# DEVIATION REQUEST AND DECISION FORM

| Project Name : | Urban Collection at Palmer Village |

A deviation from the standards of or in Section **2.3.2 – Design Standards by Functional Classication, Table 2-7 – ADT** of the Engineering Criteria Manual (ECM) is requested.

PALMER VILLAGE
PUD DEVELOPMENT/PRELIMINARY PLAN
GRADING & UTILITY

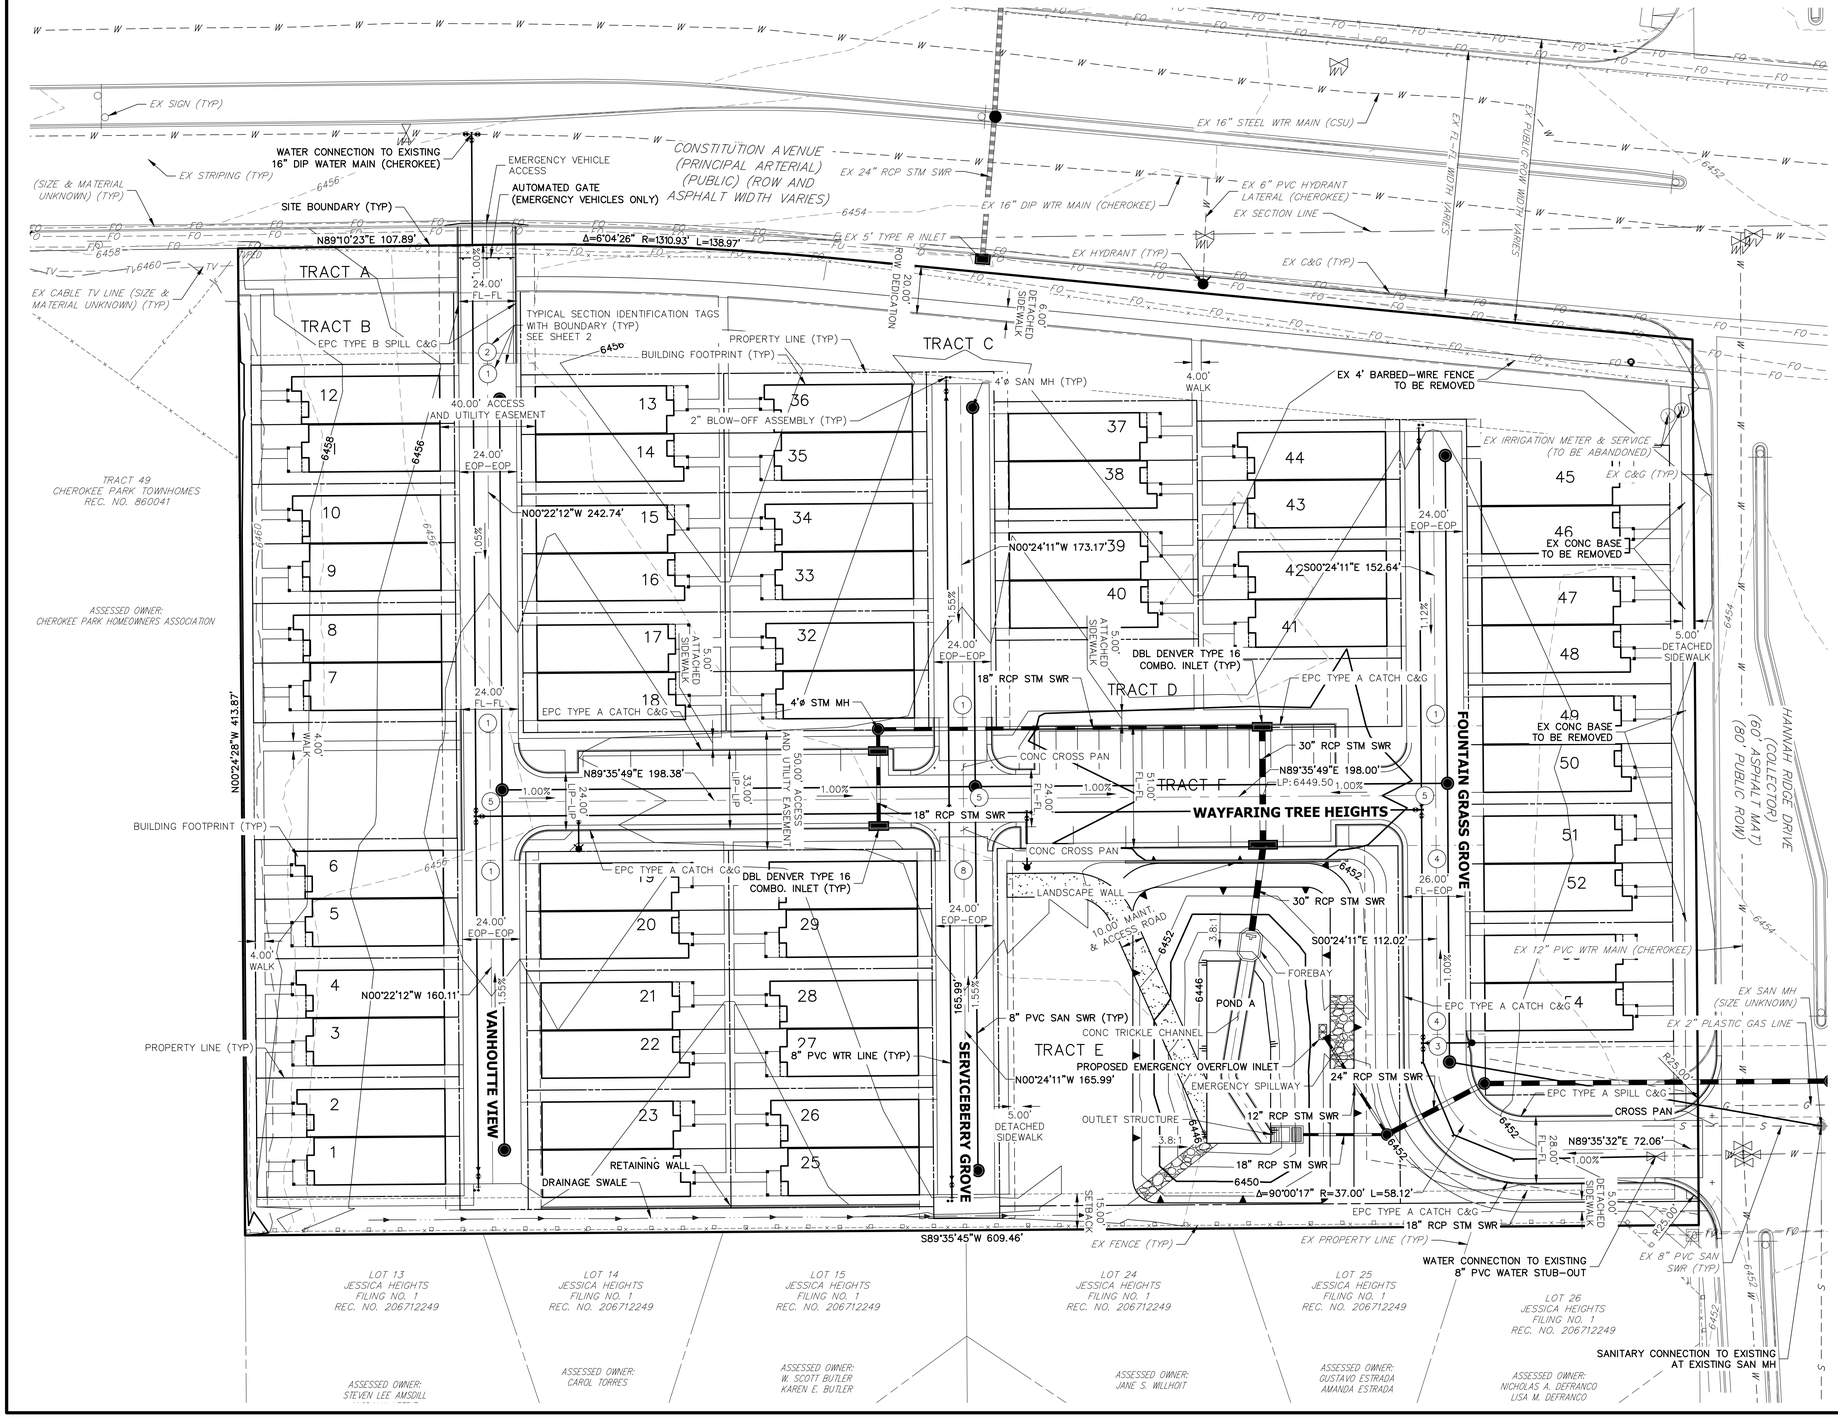
The ADT for each parcel (west and east) is anticipated to be 395 and 337, respectively. See Preliminary Plan in Attachment #2 for layout of the development. The development will utilize alleys (private) for accesses to each of the units. The low anticipated traffic demand for the neighborhood better aligns with the Local (Low Level) roadway classification.
